**ADDENDUM NO. 1
06/04/26**

SPECIFICATION NO. 26-11757-C

CITY OF BERKELEY

**SANTA FE TRACKBED TO PARK CONVERSION
New Community Gardens, Dog Park, and Playground**

MATERIALS PLAN - DERBY TO WARD
SHEET TITLE:

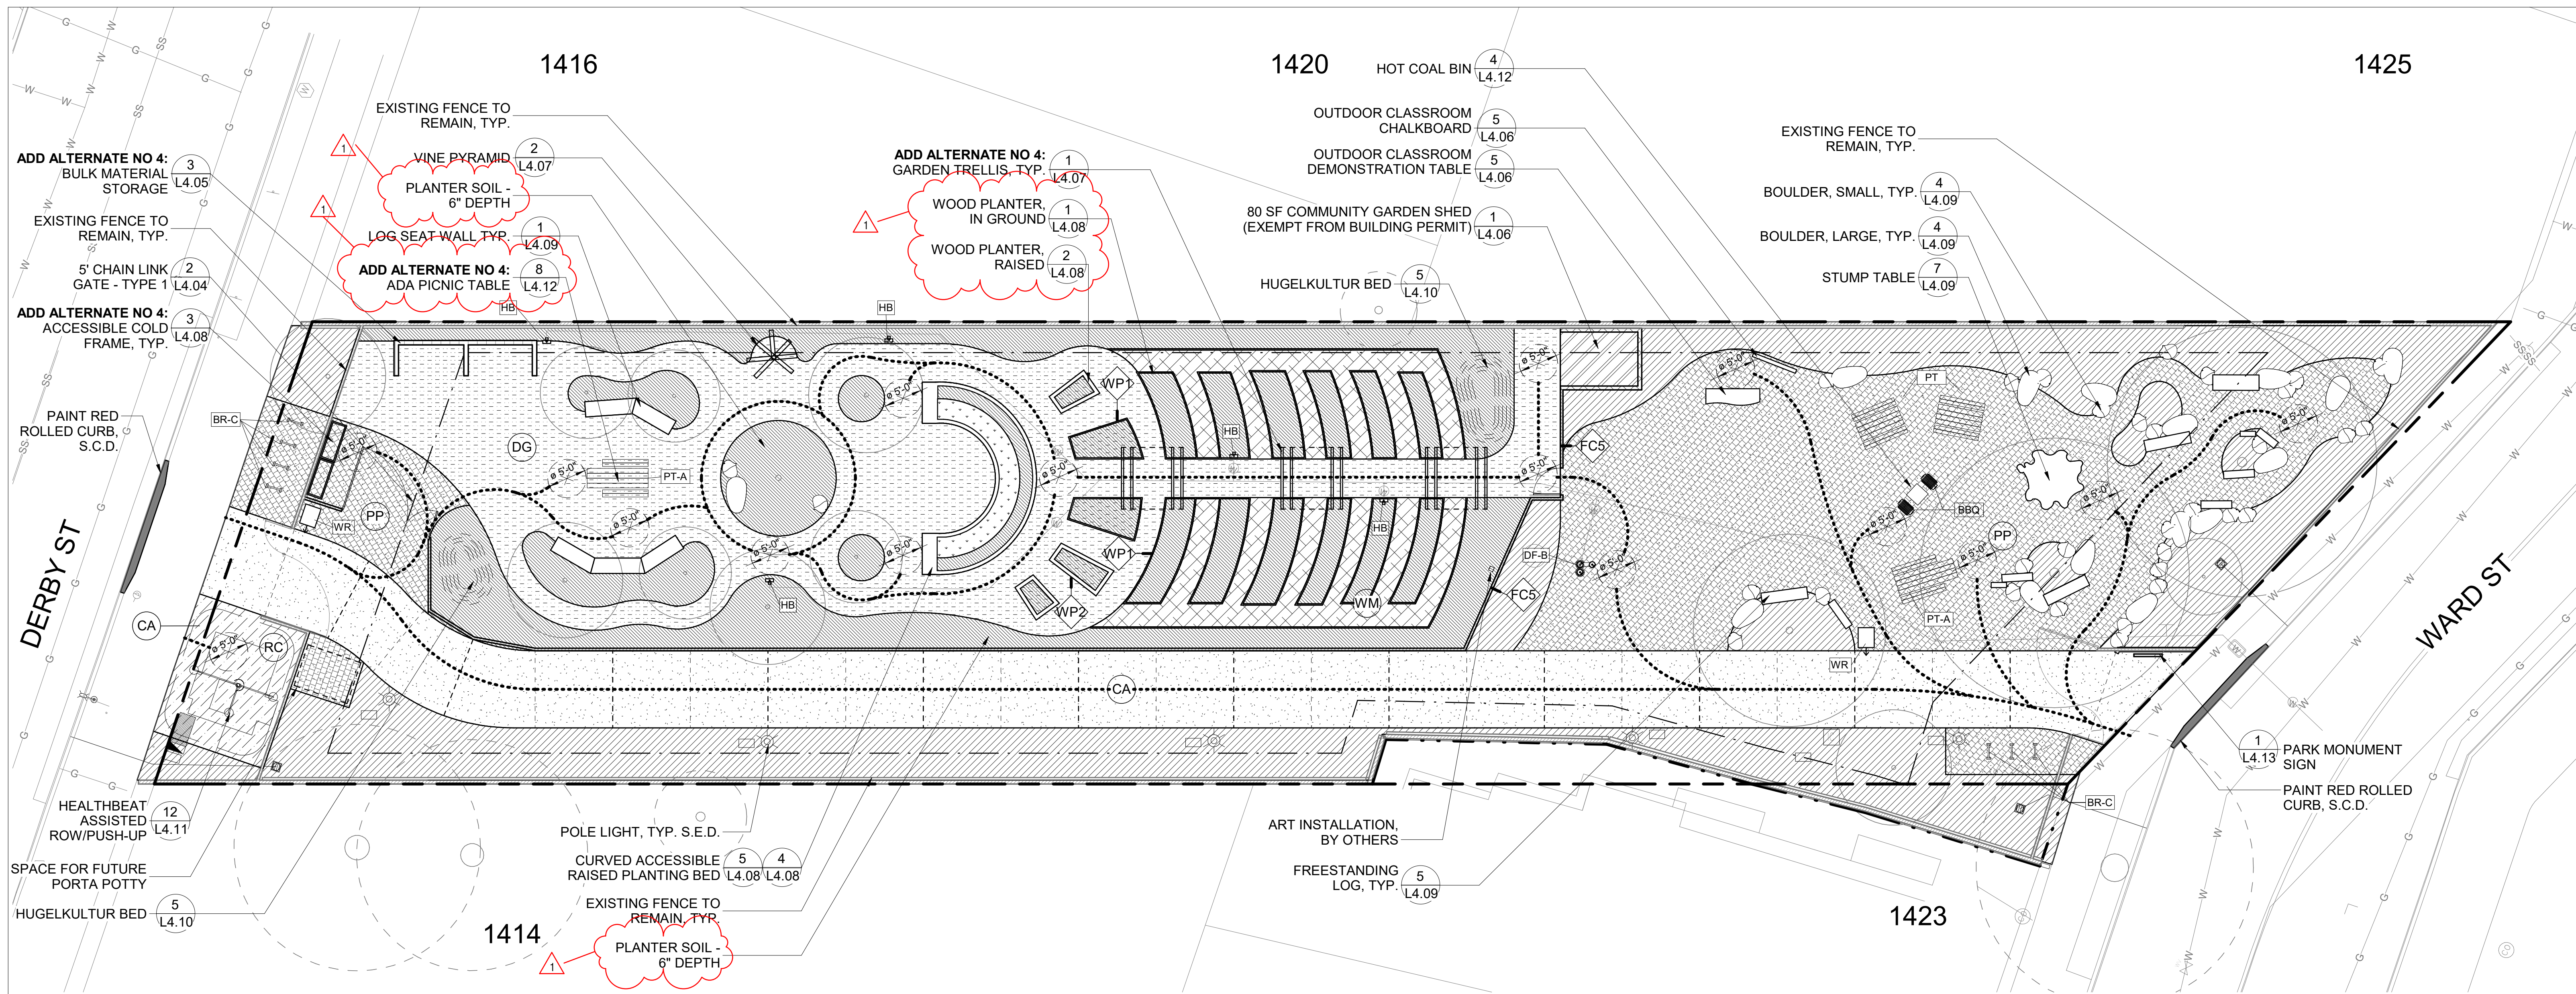
36. Please provide bid items for planter soil mix to be installed at raised planters and in-ground planters as shown on Sheet L1.04 (Derby to Ward – Parcel 4).

Response Bid item 4.24 Planting Soil Mix is for all planter soil mix as shown on Sheet L1.04 (Derby to Ward – Parcel 4).

1 CONCRETE PAVING
L4.01 3/4" = 1'-0"

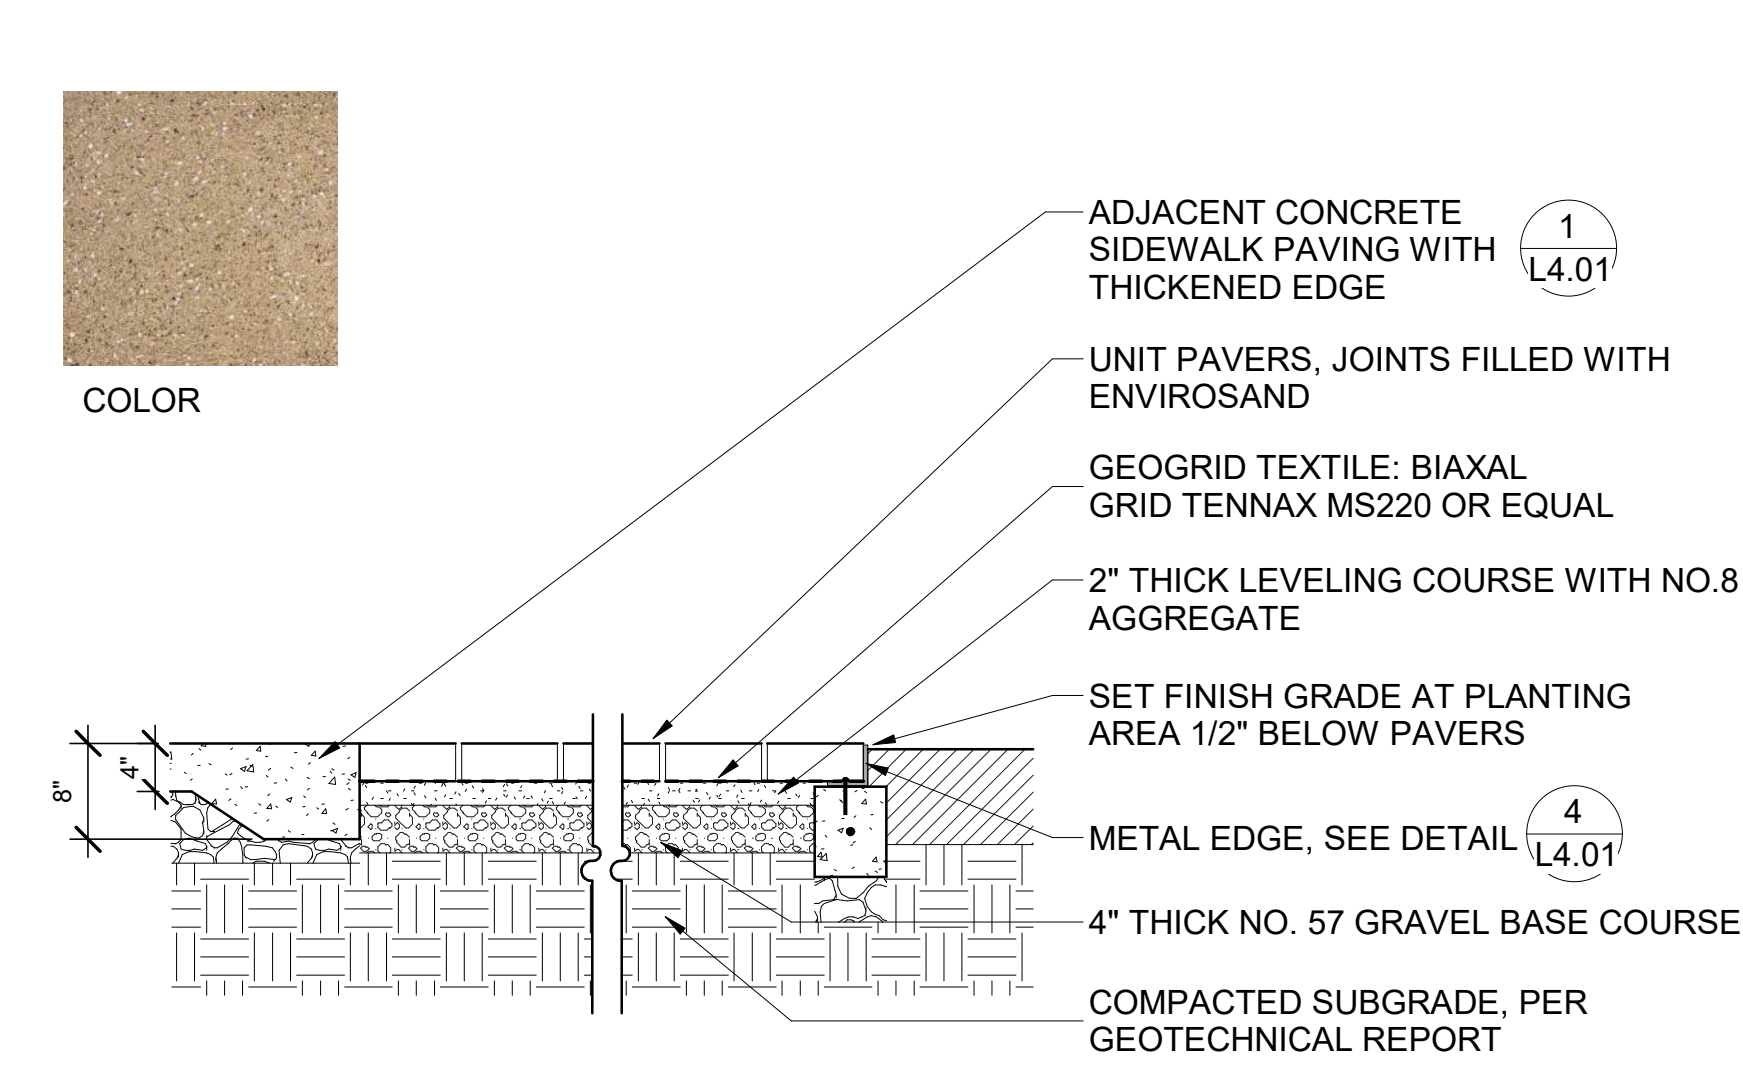
16. Please confirm the use of No. 57 Gravel Base under all concrete as shown on detail 1/L4.01.

Response Base revised to Class 2 AB. See revised detail.

3 STABILIZED DECOMPOSED GRANITE PAVING
L4.01 1" = 1'-0"

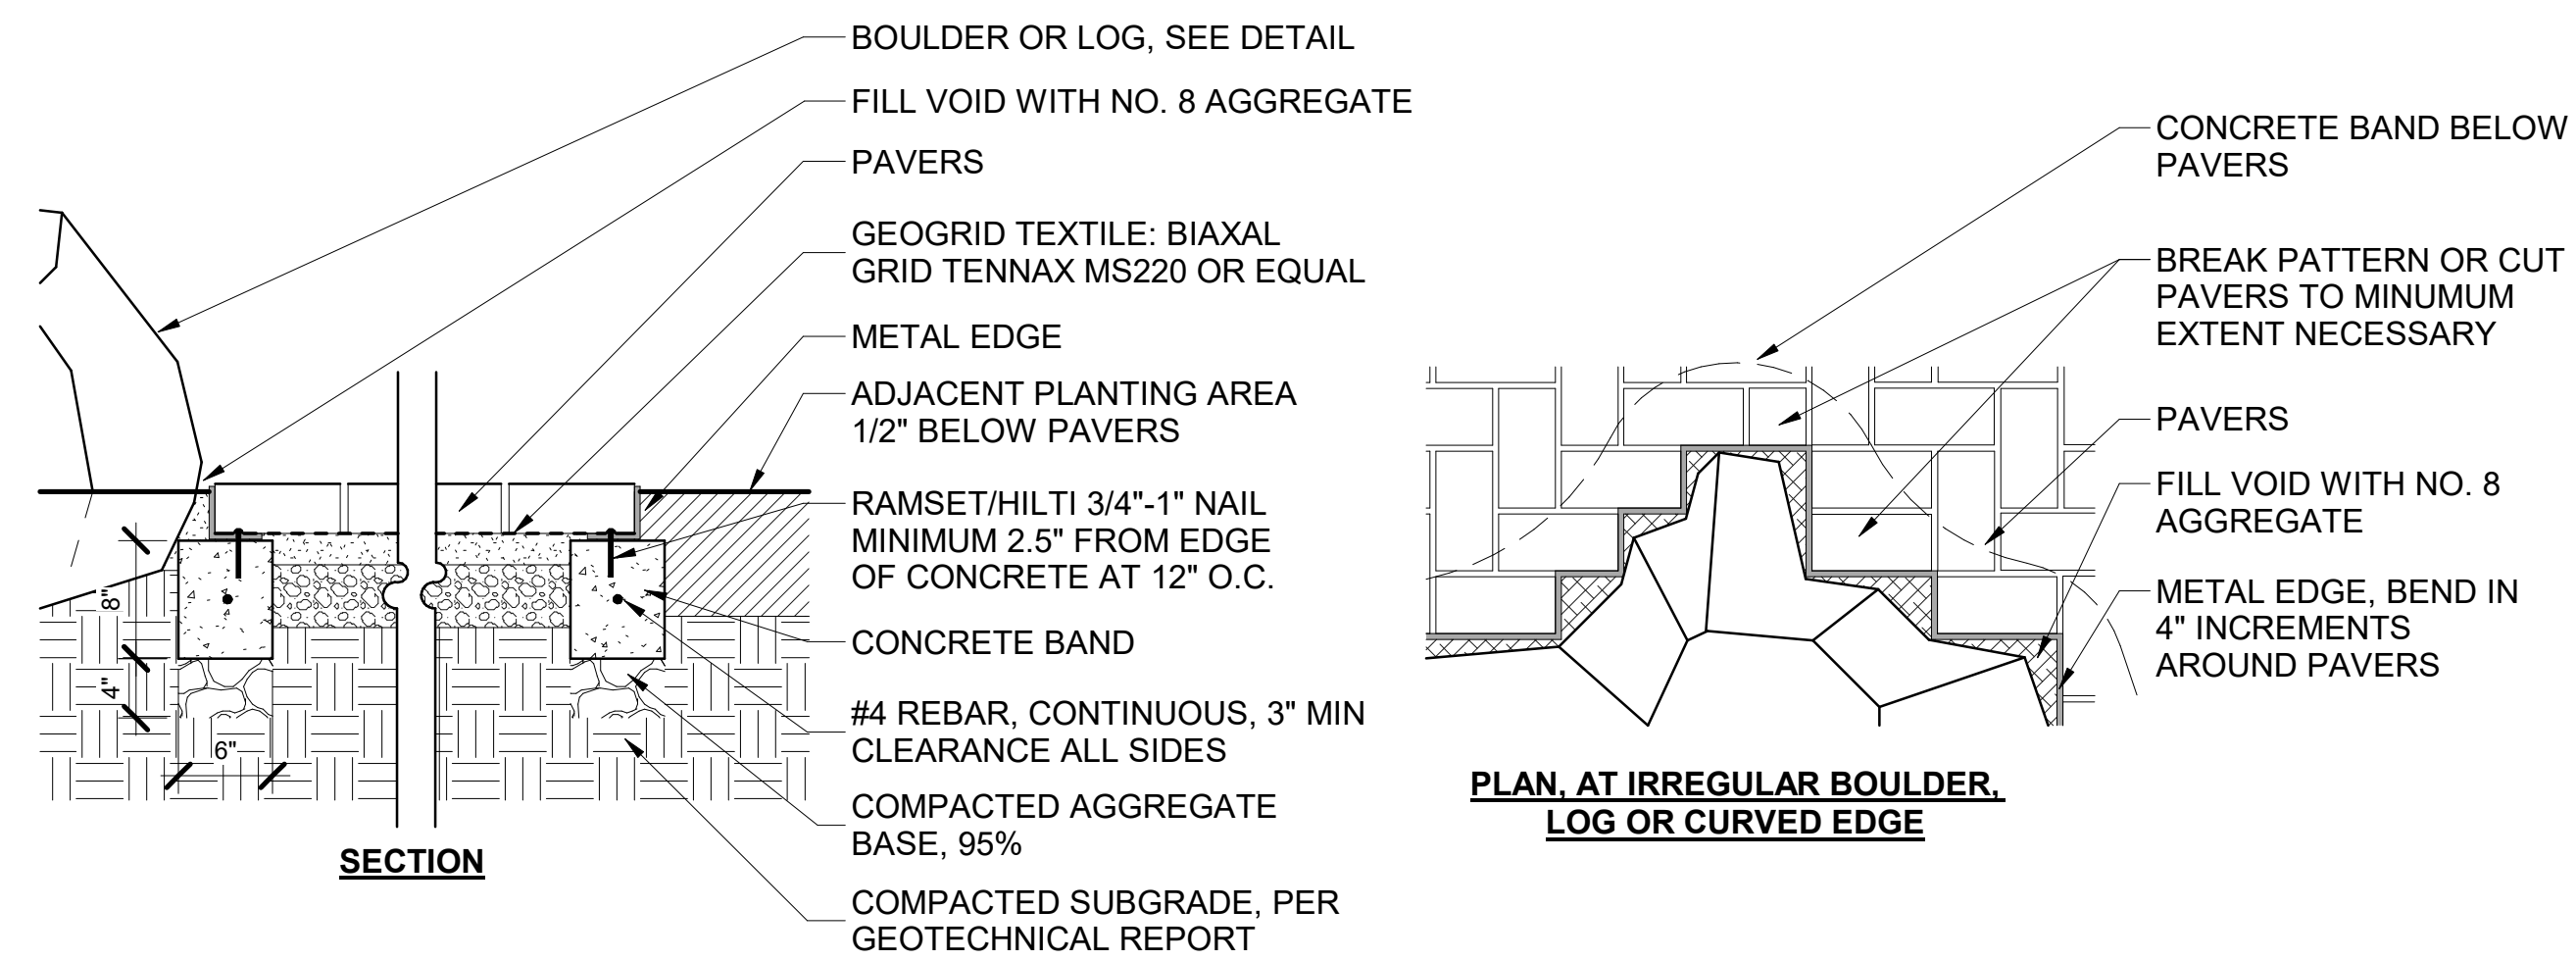
33. Detail 3/L4.01 indicates a 3" x 3" Permaloc Aluminum Edging (AsphaltEdge) at stabilized decomposed granite; however, Specification Section 32 90 00 (Part 2.12) requires a 1/8" x 1-5/8" aluminum edge restraint. Please confirm which type is required. Additionally, please advise whether this edging is included as part of the stabilized decomposed granite paving item. If not, please provide a separate bid item.

Response Use edging specified in the detail. Edging product removed from specification.

1 X CHAIN LINK FENCE
L4.04 3/4" = 1'-0"

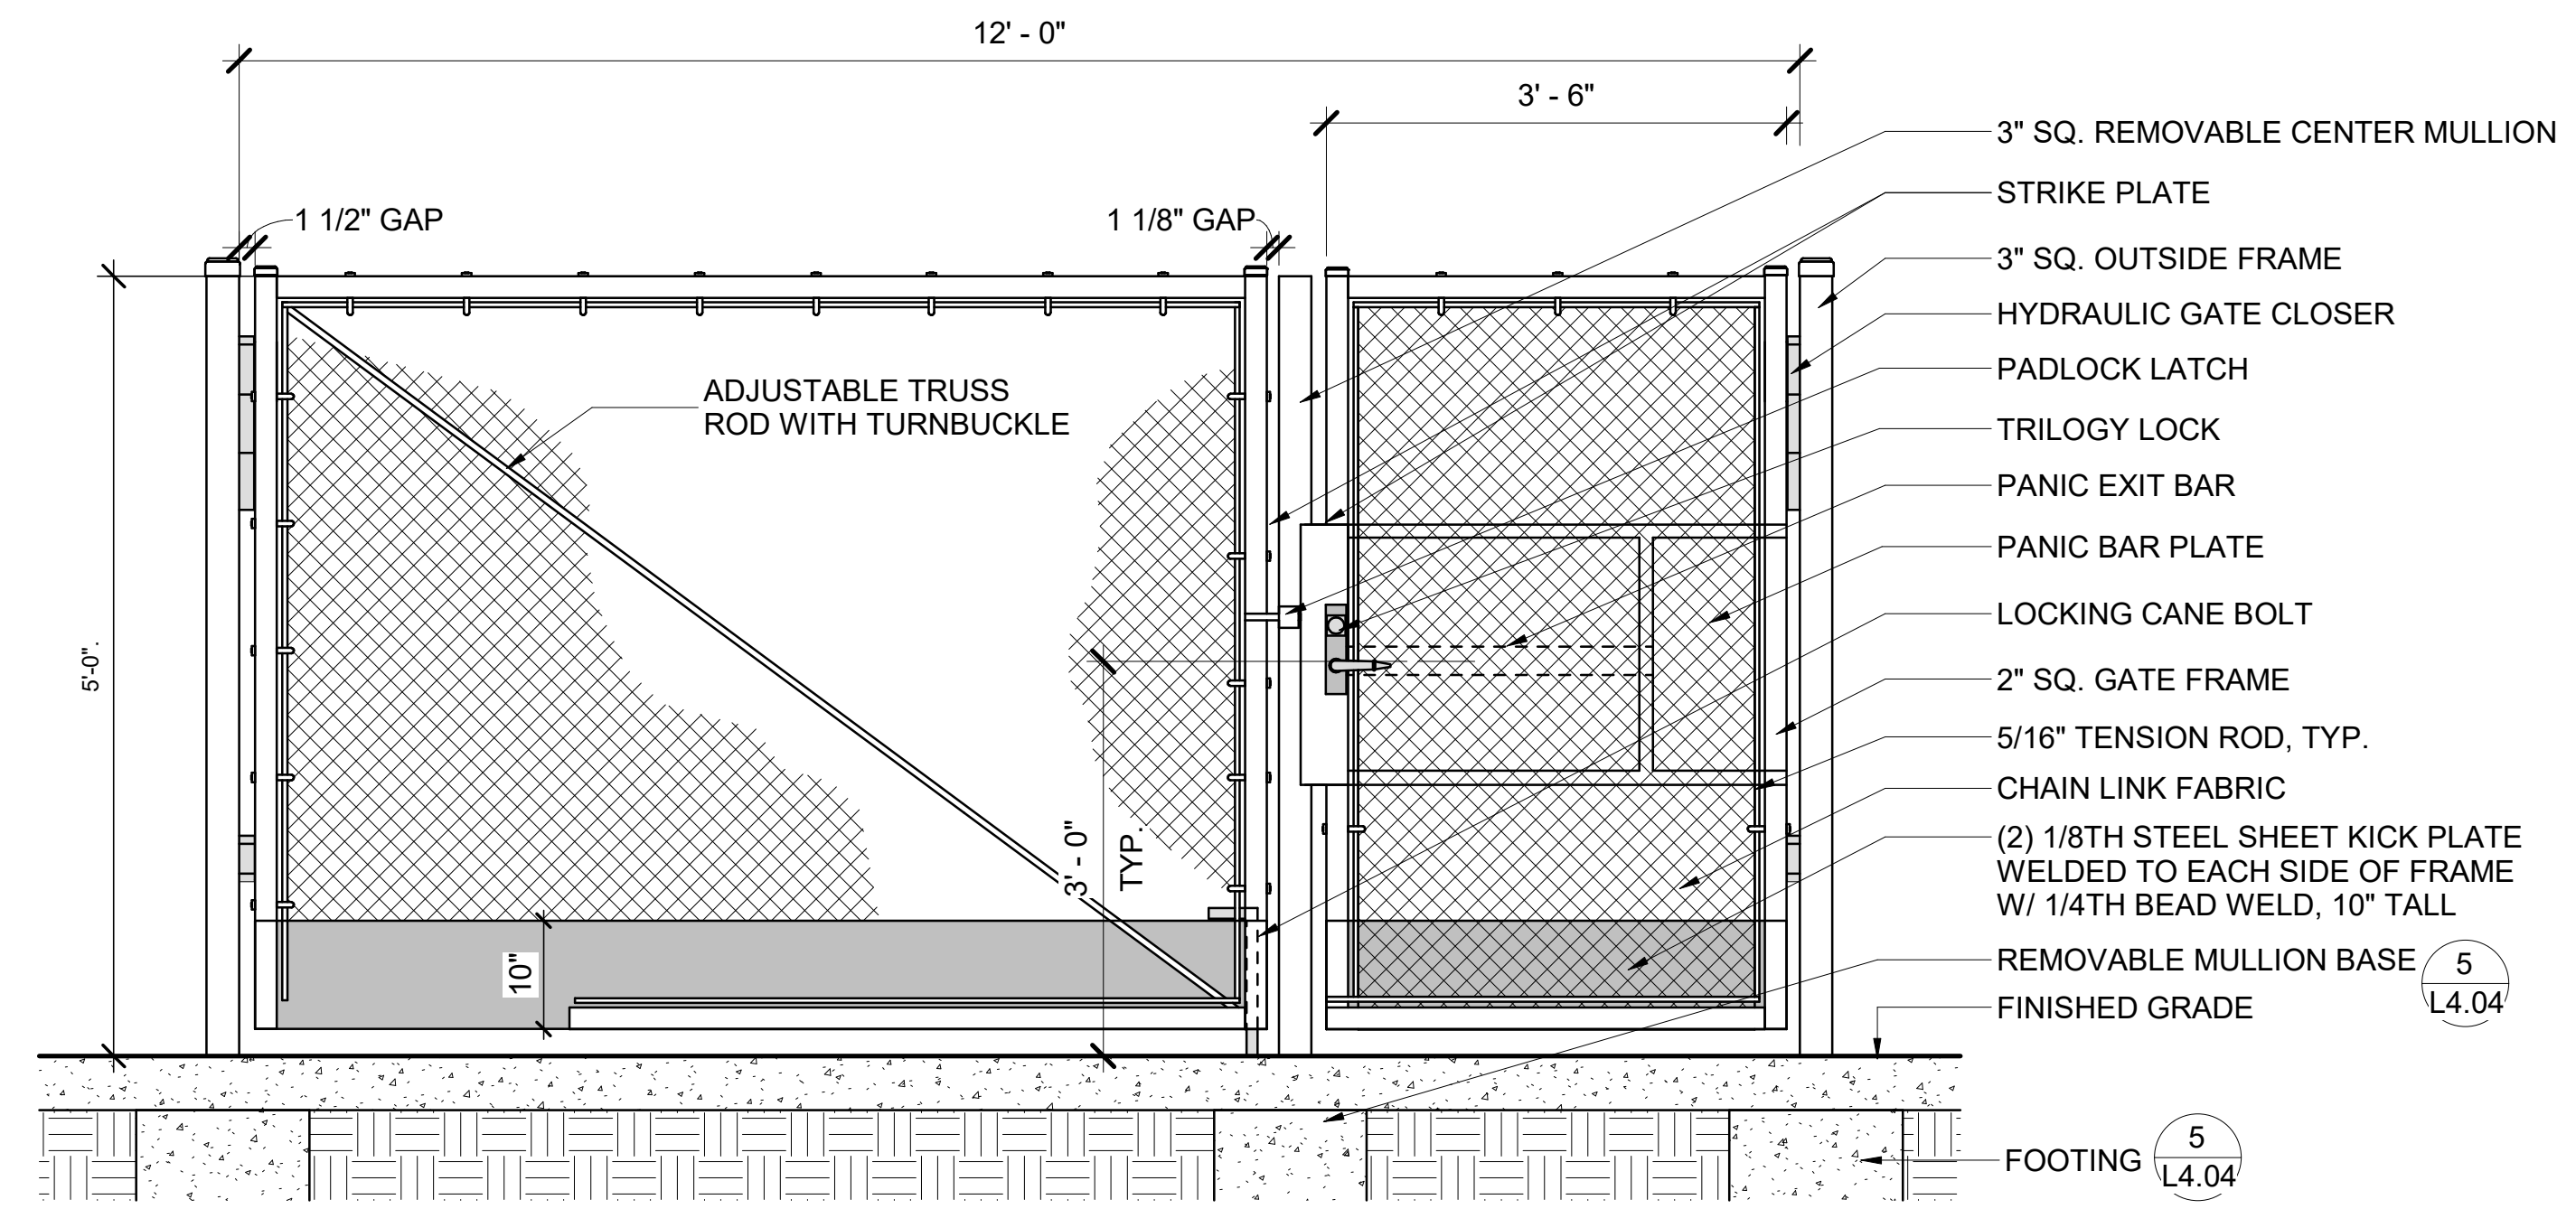
40. [Chain Link] The plan details clearly call out a "standard" (11 gauge x 2") mesh while the specifications makes references to (slatted) mesh. Given the application, I would assume that these references in the specifications can be ignored but can you please confirm?

43. [Chain Link] The plan detail calls for 2" rails. This is not a typical installation and will result in higher cost components at no obvious benefit to the design. Would a standard 1-5/8" rail be an acceptable substitute for this component?

Response Chain link fence shall not be slatted.

Response No. 2" rails are desired for public park applications.
